Technology Inclusive Content of Application Project (TICAP), and Advanced Reactor Content of Application Project (ARCAP) Meeting

December 10, 2020

NRC Comments on Draft Southern Company TICAP Guidance Document

Discussion of NRC Comments on NEI Guidance Document Annotated Outline

Chapters 6&7 – Safety-Related and NSRST SSC Criteria and Capabilities

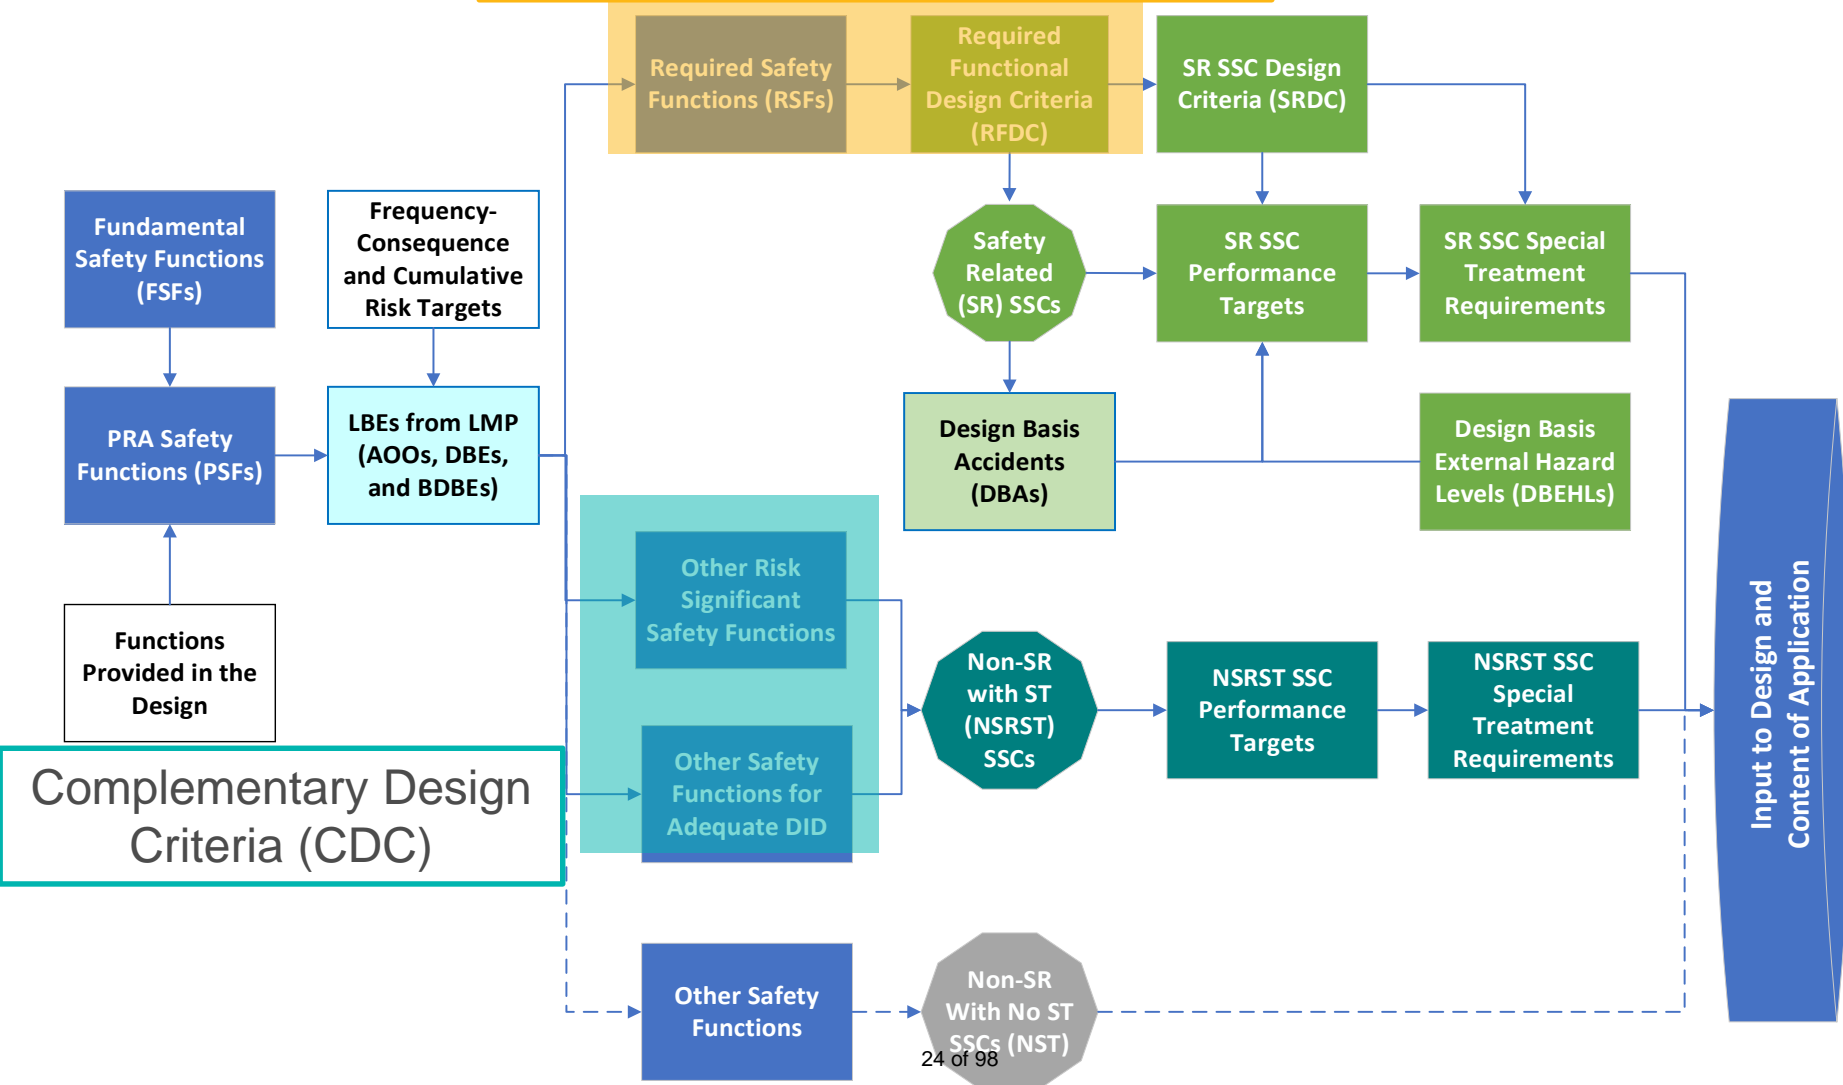
NRC question: This section includes a description of the Safety-Related Design Criteria. It's not clear how this set of criteria is related to the Principal Design Criteria and the Complementary Design Criteria reflected in SAR Chapter 5.

NRC question: This section seems to be missing a reference to Complementary Design Criteria.

TICAP response: The Safety-Related Design Criteria flow down from the Principal Design Criteria (PDC) as discussed in the August 27, 2020 Stakeholder Meeting. See also next slide.

TICAP response: The Complementary Design Criteria for NSRST SSCs will be identified in Chapter 5, in an analogous manner to the identification of PDC for Safety-Related SSCs in the same Chapter.
